Model
1996-99
3.5 Legend
1996-98
3.2TL

Bulletin No.
99-538
Issue Date
AUGUST 1999

Safety Recall: Extension Shaft Sealing Bolt

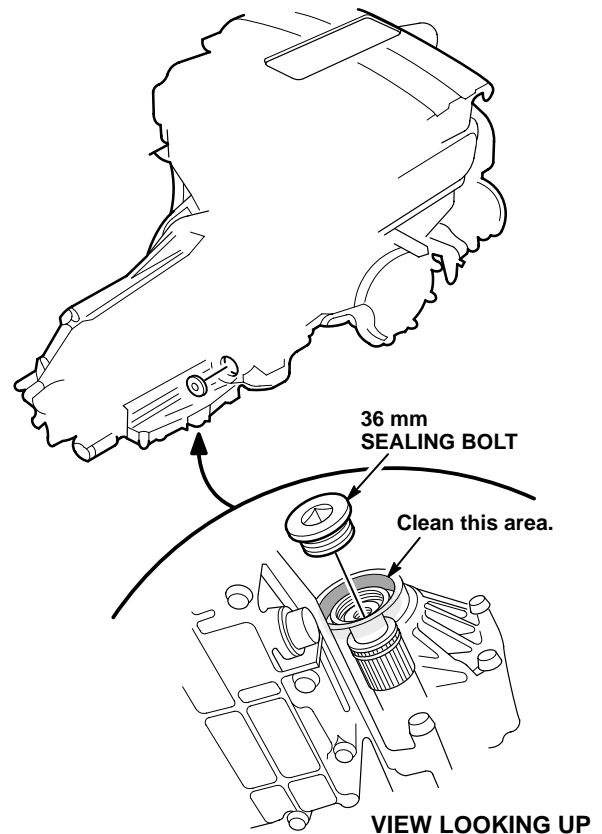
The 36 mm sealing bolt on the side of the transmission housing may loosen and fall out. If this occurs, the extension shaft may back out and disconnect from the differential. If this happens while driving, the car loses power to the drive wheels without warning. If the car is stopped with the transmission in Park and the parking brake not engaged, the car could move unexpectedly.

Replace and properly torque the 36 mm sealing bolt.

36 mm Sealing Bolt Set: P/N 90082-PY5-305
(The set includes a new sealing bolt and O-ring.)

3. Remove the 36 mm sealing bolt.
4. Use brake cleaner and compressed air to clean the threads in the transmission housing. Wear eye protection.
5. Install the O-ring on the new sealing bolt.
6. Install the new 36 mm sealing bolt. Do not use any thread lock or thread sealer. Torque the bolt to 78 N-m.
7. Lower the vehicle.
